Access Compliance Report Public Rights-of-Way (Curb Ramps)

Main Street: GARZA_AVE Cross Street: N/A Location: NE

ADA ID: RPAT220202101537 Ramp Type: Type 4 - Parallel Initial Pass/Fail: Fail Overall Compliance: No Severity Score: 4

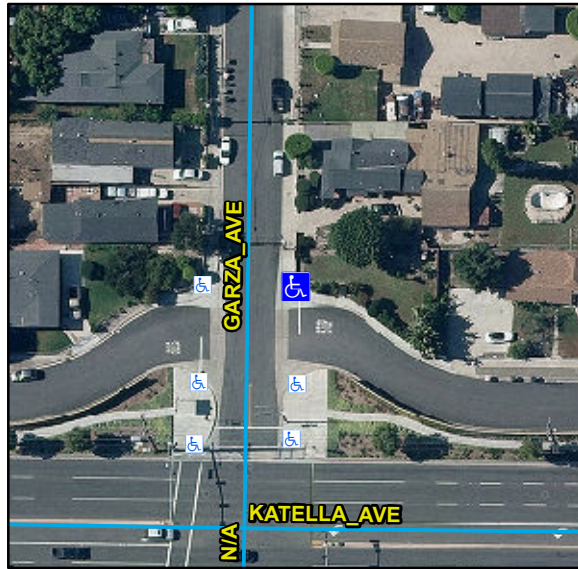
Compliance	Description	Data	Compliance	Description	Data
N/A	Ramp Length LT (in)	94	N/A	Ramp Length RT (in)	106
No	Ramp Width LT (in)	47	No	Ramp Width RT (in)	47
Yes	Ramp Run Slope LT (%)	7.24	Yes	Ramp Run Slope RT (%)	7.3
Yes	Ramp Cross Slope LT (%)	0.7	Yes	Ramp Cross Slope RT (%)	0.2
N/A	Landing Present	N/A	N/A	DWS Provided	N/A
N/A	Landing Length (in)	N/A	N/A	DWS Contrast	N/A
N/A	Landing Width (in)	N/A	N/A	DWS Length (in)	N/A
N/A	Landing Run Slope (%)	N/A	N/A	DWS Full Width	N/A
N/A	Landing Cross Slope (%)	N/A		DWS Offset Type	N/A
N/A	Landing Movement Obstructed?	N/A	N/A	DWS Offset Left (in)	N/A
	Landing Movement Type	N/A	N/A	DWS Offset Right (in)	N/A
N/A	Landing Shared	N/A			
N/A	Clear Space	Yes			
N/A	Clear Space To Crosswalk (in)	N/A			
N/A	Marked Crosswalk 1	No	N/A	Marked Crosswalk 2	No
	Crossing 1 Direction	W		Crossing 2 Direction	S
	Marked Crosswalk 1 Width (in)	N/A		Marked Crosswalk 2 Width (in)	N/A

Remove & Replace Curb Ramp With Two New Directional Ramps or Equivalent.
